S.S. "FRATERNITAS".

Dimensions:- 470' x 58' x 35.41'

W133-0096 (2/2)

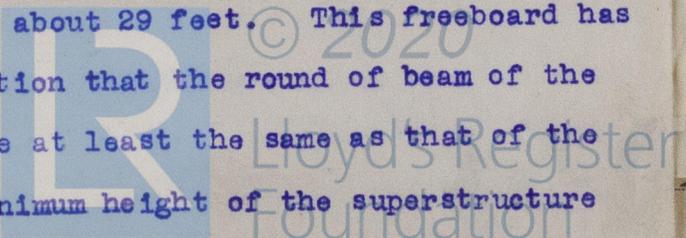
A proposal to fill in the wells, thus forming a complete superstructure erection, and to arrange a skidway at the after end, was dealt with on the 5th instant.

A further letter has now been received from the Gothenburg Surveyors stating that the additional strengthening indicated on the plans dealt with on the 5th instant will be effected, and that a detail plan of the proposed pillars and girders will shortly be submitted for approval. In the meantime the Owners desire to be informed of the minimum freeboard which could be assigned to this vessel, and also of the additional strengthening to the hull which would be required.

It is submitted the Surveyors be informed that as, among other items, the bulkheads of the oil tanks are not carried up to the freeboard deck, tanker freeboards cannot be assigned, but if a superstructure as proposed is fitted for the whole length of the vessel with scantlings as shewn and amended on the plan submitted, <sup>and amended on the 5th inst.</sup> but the thickness of the superstructure deck made .48, instead of .40, the minimum freeboard which could be assigned as for a cargo vessel would be that corresponding to a summer moulded draught of about 29 feet. This freeboard has been computed on the assumption that the round of beam of the superstructure deck would be at least the same as that of the freeboard deck, that the minimum height of the superstructure

would be 7'-0" with 3" sheathing thereon, and that all openings in the superstructure deck, would be closed by companionways or hatchways with efficient closing appliances, and that any openings in the sides of the superstructure would be closed weathertight.

With the scantlings of the superstructure as shewn and amended on the plan approved on the 5th instant, but the superstructure in all other respects fulfilling the conditions indicated above, a freeboard corresponding to a summer moulded draught of about 28'-5" could be assigned.

When the alterations are effected full particulars should be supplied on form C.11 for freeboard assignment.

The Surveyors will require to satisfy themselves in all respects regarding the condition of the main hull structure.
